Department of Energy  
Washington, DC 20585

NOV 26 1991

U.S. DEPARTMENT OF ENERGY'S RESPONSE  
TO U.S. NUCLEAR REGULATORY COMMISSION'S  
SITE CHARACTERIZATION ANALYSIS (SCA) OBJECTION 1

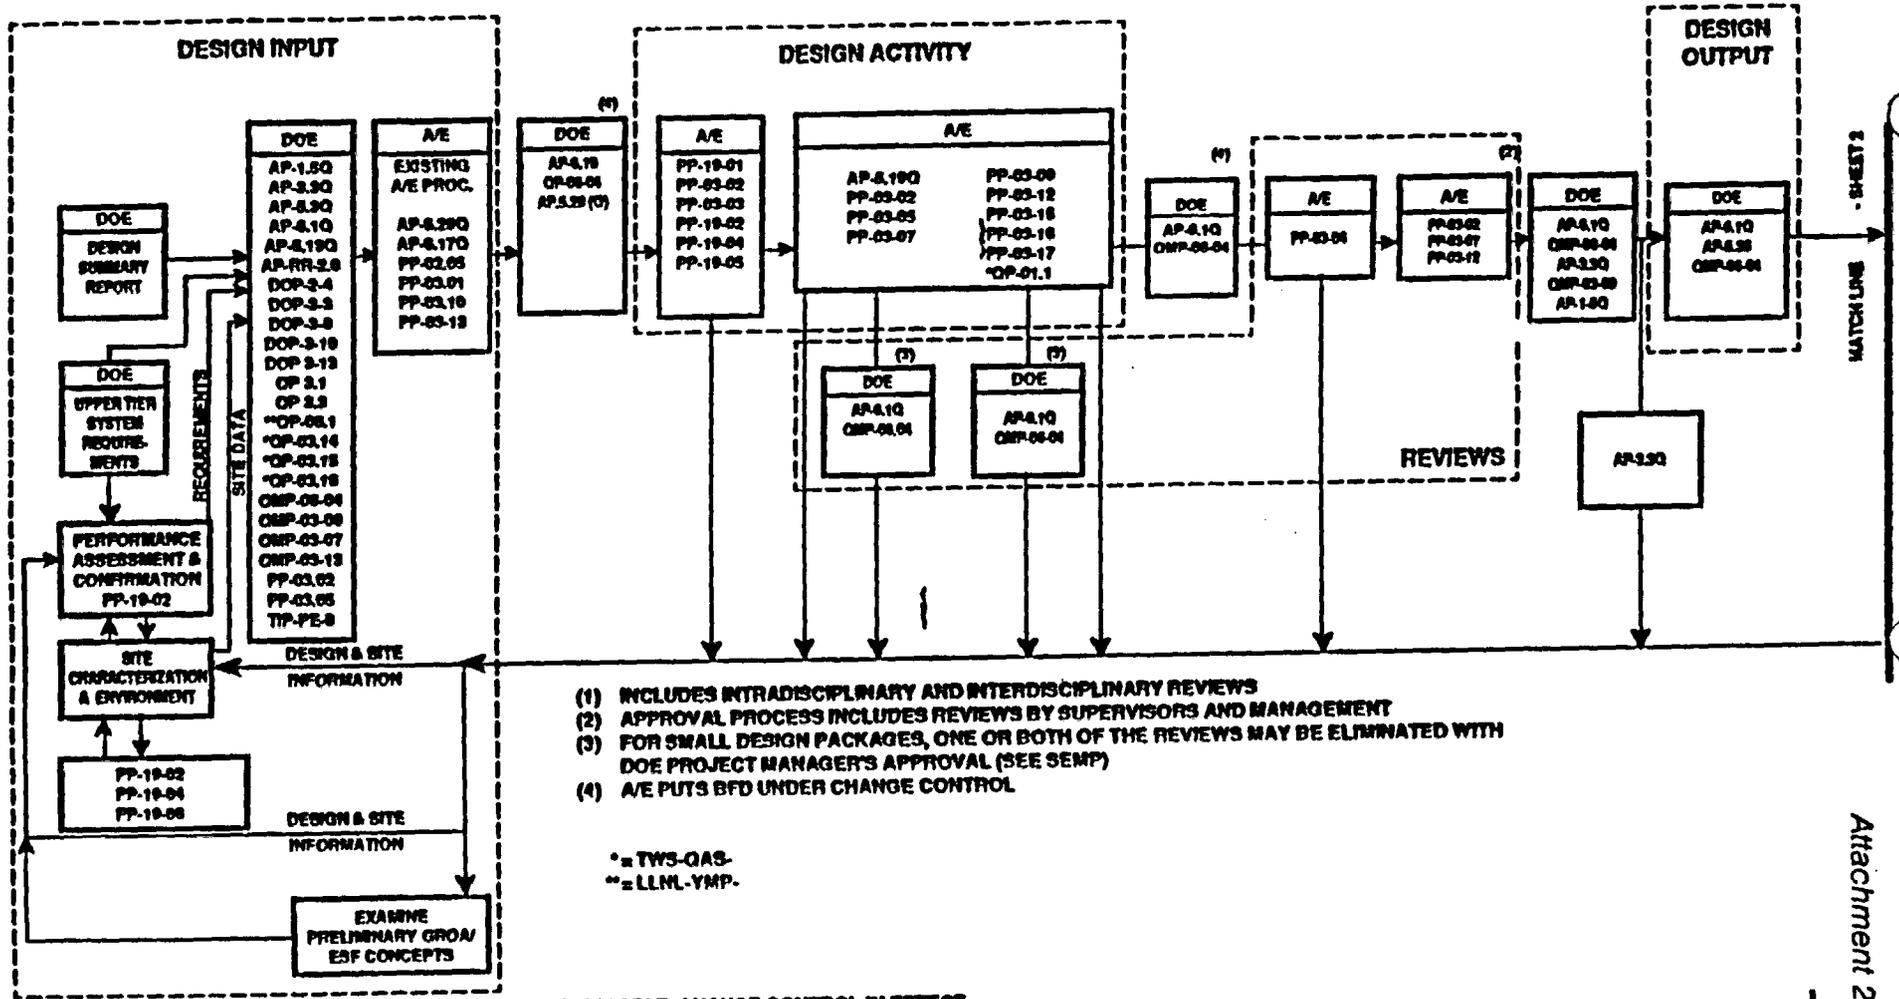
- 18 e. The location of the canister-scale heater test shown in Figure 8.4.2-39 (p. 8.4.2-209) has been erroneously indicated on the layout. As a result, its zone of influence apparently overlays the heated block test. In addition, the SCP gives the following two constraints for locating the canister scale heater test (p. 8.4.2-120):

- located greater than 9 m from drifts or alcoves running parallel to the axis of the heater.
  - located in a "low traffic" area.

Neither of these constraints has apparently been met.
- 19 f. The locations of several major tests identified in the SCP have not been specifically identified. These include some tests that could have a considerable zone of influence (e.g., Heated room experiment) and some that require extensive test area (e.g., Horizontal drilling demonstration test). Examples of other tests for which specific locations have not been identified include thermal stress measurements, development and demonstration of required equipment, three of the four diffusion tests identified on p. 8.4.2-140, seal tests and other performance confirmation tests.

During Title II design, test planning packages per AP 5.32Q will address test positioning and the MTL layout will be re-evaluated for test interferences. At that point, the configuration is likely to change, obviating the need to change this particular figure. This information will be included in the Title II Design Summary Report.
